Access Compliance Report

Public Rights-of-Way

(Curb Ramps)

Intersection ID: 12160	Main Street: E_9TH_ST	Cross Street: N_BREVARD_ST	Location: W
ADA ID: 65C328ADCEC7	Ramp Type: Perpendicular	Initial Pass/Fail: Fail	Overall Compliance: No
Severity Score: 12.5			
Codes/Mitigation Info/Possible Solution		Field Measurements/Component Compliance

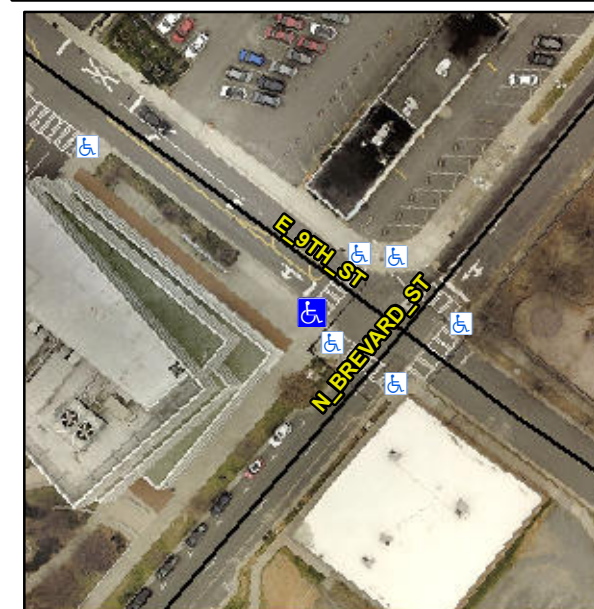
Not Found, R304.2.2

Compliance	Description	Data	Compliance	Description	Data
N/A	Ramp Length (in)	72.0	No	Ramp Slope (%)	8.8
Yes	Ramp Width (in)	48.0	Yes	Ramp XSlope (%)	1.9
N/A	Flare Type LT	N/A	N/A	Flare Type RT	N/A
N/A	Flare Slope LT (%)	N/A	N/A	Flare Slope RT (%)	N/A
N/A	Flare Traversable LT?	N/A	N/A	Flare Traversable RT?	N/A
N/A	Landing Length (in)	N/A	N/A	DWS Provided?	N/A
N/A	Landing Width (in)	N/A	N/A	DWS Contrast?	N/A
N/A	Landing Slope (%)	N/A	N/A	DWS Length (in)	N/A
N/A	Landing X Slope (%)	N/A	N/A	DWS Full Width?	N/A
N/A	Landing Curb? (Y/N)	N/A	N/A	DWS Offset (in)	N/A
N/A	Shared Landing?	N/A			
N/A	Gutter Ponding?	N/A	N/A	Gutter Slope (%)	N/A
N/A	Gutter Lip Ht (in)	N/A	N/A	Gutter X Slope (%)	N/A
N/A	Painted X Walk1?	Yes	N/A	Painted X Walk2?	N/A
	X Walk 1 Direction	To NE		X Walk 2 Direction	N/A
N/A	X Walk 1 Width (in)	104.0	N/A	X Walk 2 Width (in)	N/A
	X Walk 1 Slope (%)	3.8		X Walk 2 Slope (%)	N/A
	X Walk 1 X Slope (%)	2.2		X Walk 2 X Slope (%)	N/A

Remove & Replace Entire Ramp.
